Access Compliance Report Public Rights-of-Way (Curb Ramps)

Main Street: SKLAR_ST Cross Street: N/A Location: N

ADA ID: RPRK211202113602 Ramp Type: Type 4 - Parallel Initial Pass/Fail: Pass Overall Compliance: No Severity Score: 25

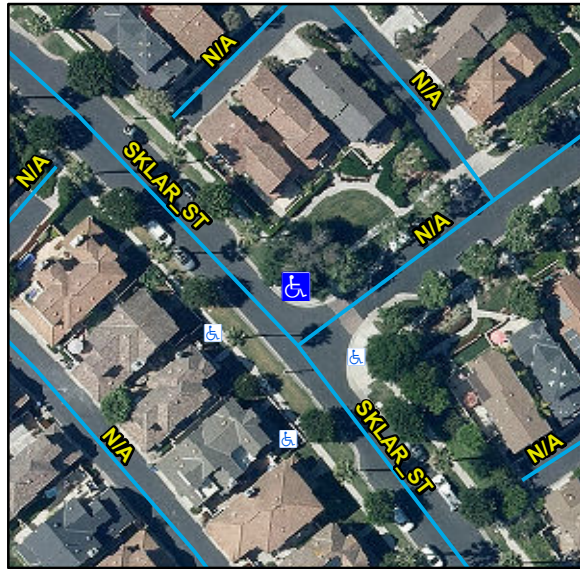
Compliance	Description	Data	Compliance	Description	Data
N/A	Ramp Length LT (in)	129	N/A	Ramp Length RT (in)	133
Yes	Ramp Width LT (in)	89	Yes	Ramp Width RT (in)	89
Yes	Ramp Run Slope LT (%)	2.8	Yes	Ramp Run Slope RT (%)	3.8
Yes	Ramp Cross Slope LT (%)	1.1	Yes	Ramp Cross Slope RT (%)	1.4
N/A	Landing Present	No	No	DWS Provided	No
N/A	Landing Length (in)	N/A	N/A	DWS Contrast	N/A
No	Landing Width (in)	N/A	N/A	DWS Length (in)	N/A
No	Landing Run Slope (%)	N/A	N/A	DWS Full Width	N/A
No	Landing Cross Slope (%)	N/A		DWS Offset Type	N/A
N/A	Landing Movement Obstructed?	No	N/A	DWS Offset Left (in)	N/A
	Landing Movement Type	Curb	N/A	DWS Offset Right (in)	N/A
N/A	Landing Shared	N/A			
N/A	Clear Space	Yes			
N/A	Clear Space To Crosswalk (in)	48			
N/A	Marked Crosswalk 1	No	N/A	Marked Crosswalk 2	No
	Crossing 1 Direction	SW		Crossing 2 Direction	SE
N/A	Marked Crosswalk 1 Width (in)	N/A		Marked Crosswalk 2 Width (in)	N/A

N/A	Ramp Inside Crosswalk 1	N/A	N/A	Ramp Inside Crosswalk 2	N/A
	Crossing 1 Slope (%)	1.2		Crossing 2 Slope (%)	2.1
	Crossing 1 Cross Slope (%)	2.2		Crossing 2 Cross Slope (%)	0.5
Yes	Gutter Ponding	No	No	Curb Slope	10.3
Yes	Gutter Lip Height (in)	0		Road Run Slope (%)	0.2
No	Gutter Run Slope (%)	6.3		Road Cross Slope (%)	4.5
Yes	Gutter Cross Slope (%)	0.5	No	Perpendicular Joint Present	No
Yes	Overall Surface Condition	Acceptable			
	Cross Gutter Present?	No		Spandrel Present?	No
	Replace Cross Gutter?	N/A		Replace Spandrel?	N/A

Remove & Replace Curb Ramp With Two New Directional Ramps or Equivalent. Remove & Replace Gutter.
